## DESCRIPTIVE REPORT

*General Locality* ..... Approaches to Sitka

*Sublocality* ..... Necker Bay

## Revisions Compiled During Office Processing and Certification

Figure 1: H11679 Survey Limits and junction overlaid on chart 17328).

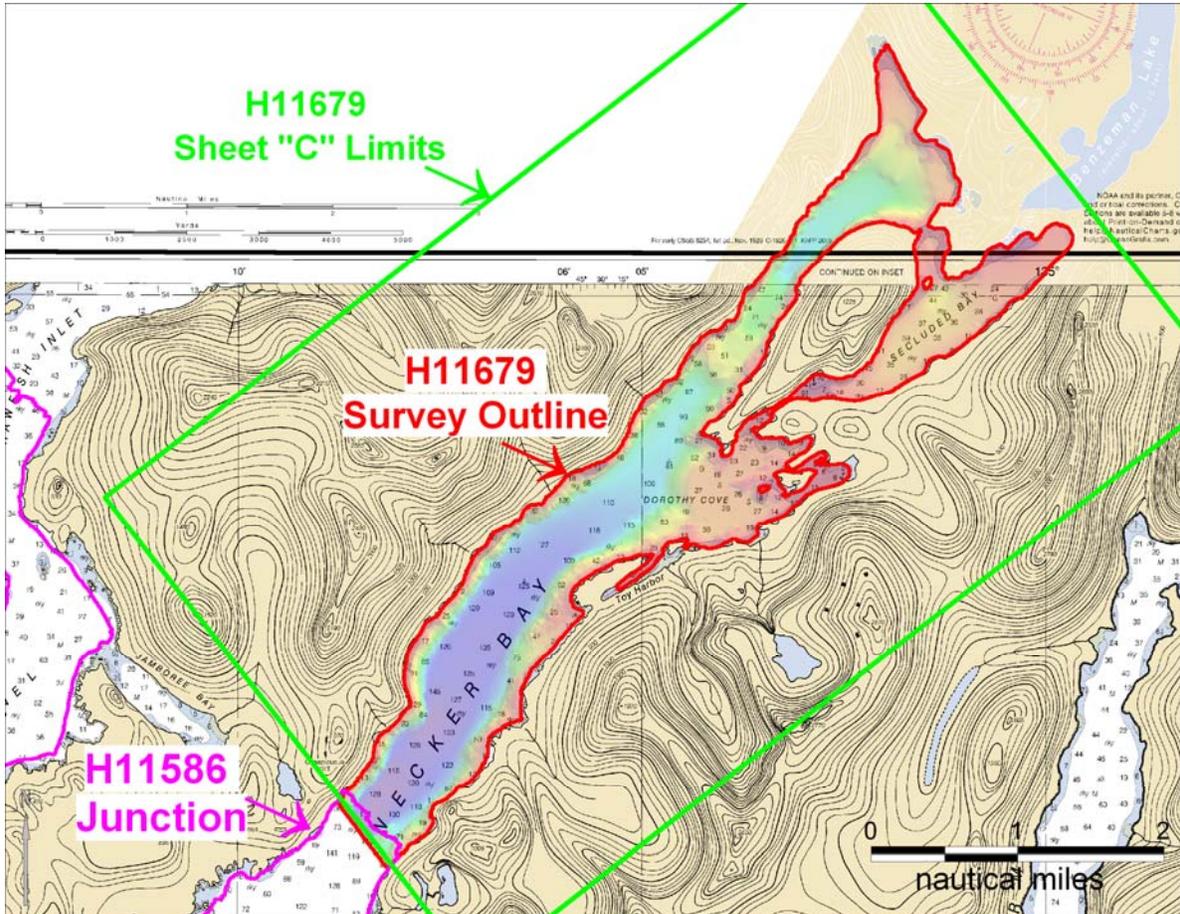
In its southwest corner, survey H11679 junctions with survey H11586 (see Figure 1 and “H11679\_updated\_plan.eml.txt” in Appendix V, Supplemental\_Correspondence)<sup>6</sup>. This survey junction near the mouth of Necker Bay was manually compared using CARIS subset mode and showed excellent agreement with no discernable differences between the two surveys.<sup>7</sup>

- <sup>4</sup> Concur.
- <sup>5</sup> Filed with project records.
- <sup>6</sup> Appended to this report.
- <sup>7</sup> Concur.
- <sup>8</sup> Concur.
- <sup>9</sup> Concur.

**Figure 21:** *Secluded Bay rocks not found.*

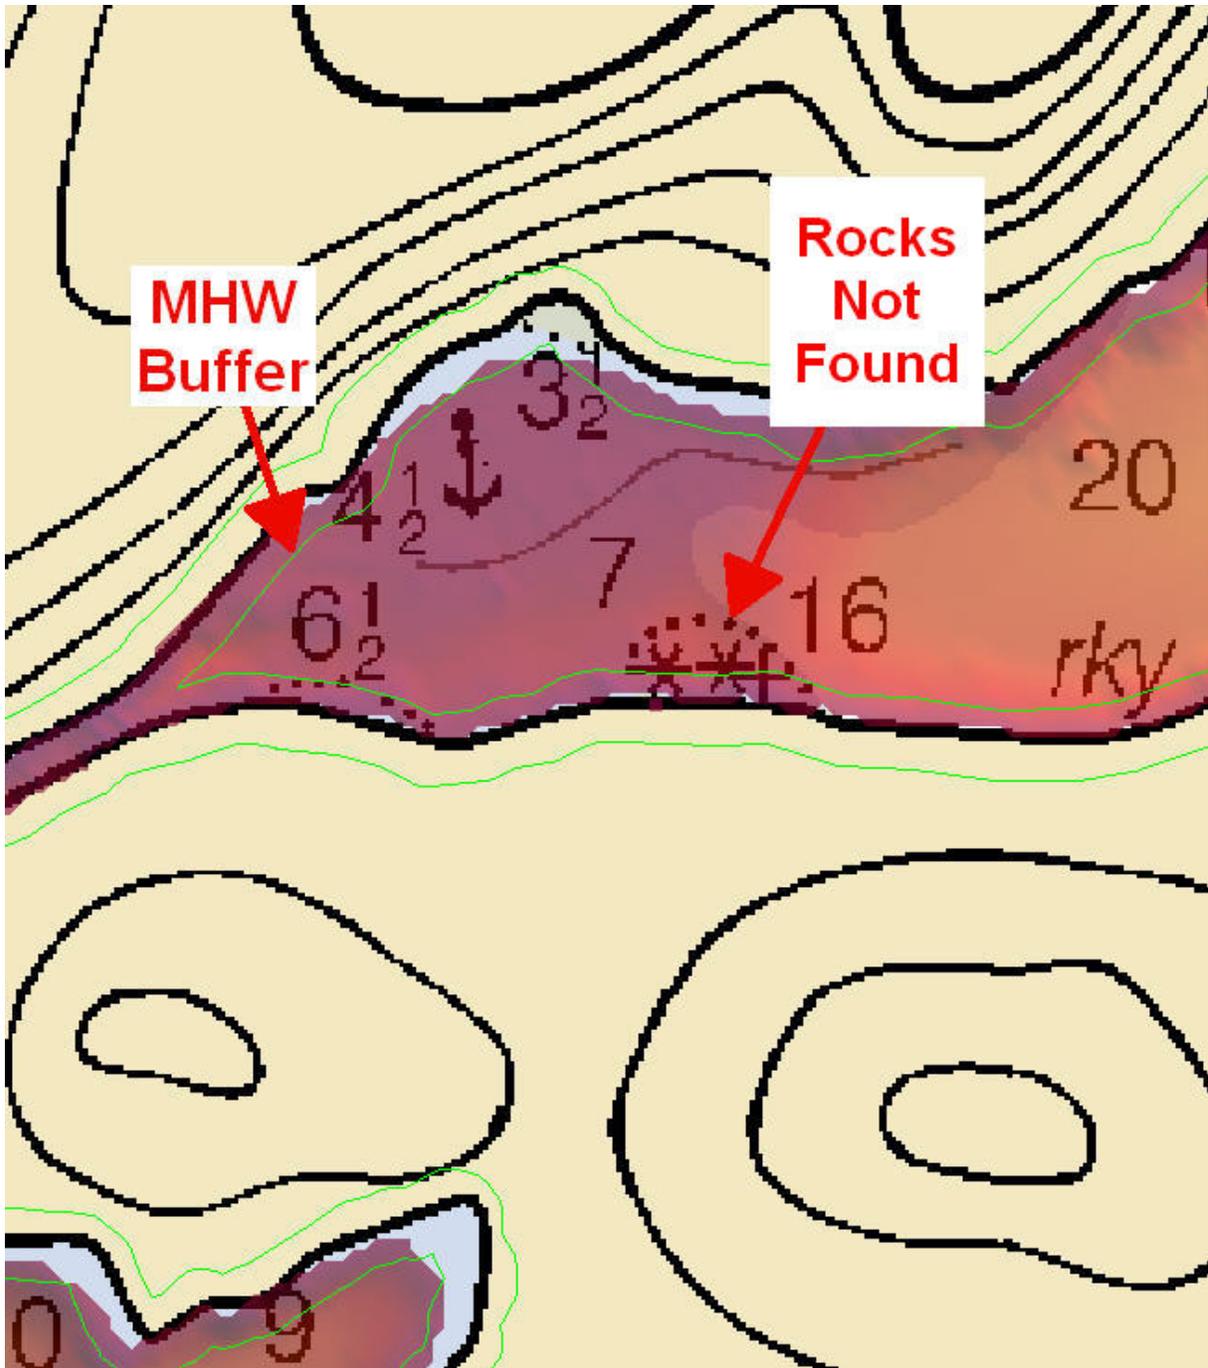
Near the southwestern entrance to Secluded Bay, along its south shoreline, complete multibeam coverage was acquired over a pair of charted rocks; the rocks were not found at the charted position (figure 21). The hydrographer recommends deleting charted rocks.<sup>22</sup>

- <sup>16</sup> Concur.
- <sup>17</sup> Concur.
- <sup>18</sup> Concur.
- <sup>19</sup> Concur.
- <sup>20</sup> Concur.
- <sup>21</sup> Concur.
- <sup>22</sup> Concur with clarification. Chart foul area as compiled to the HCell.

**Figure 22:** Dorothy Cove shoal areas.

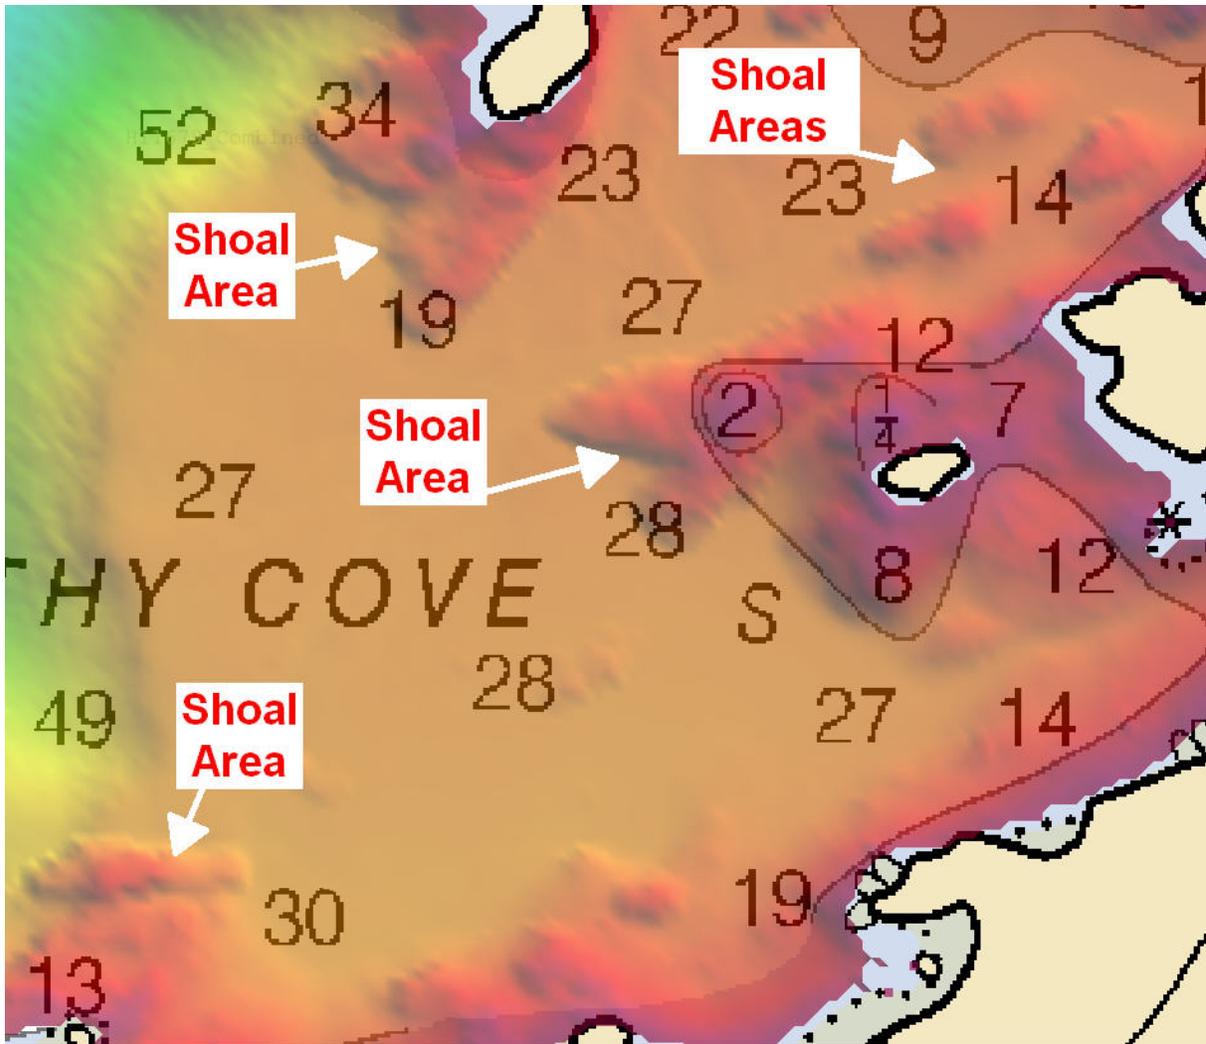
Several areas within Dorothy Cove, which provides anchorage, were found to be shoaler than previously charted. The two DTONs (see section D.1.b) submitted as part of this survey relate to the shoal areas with  $\frac{1}{4}$  and 2 fathom soundings shown on the updated raster chart (figure 22).<sup>23</sup>

- <sup>23</sup> DtoN report has been appended to this document.
- <sup>24</sup> Concur.
- <sup>25</sup> Concur.
- <sup>26</sup> Concur.
- <sup>27</sup> Concur.
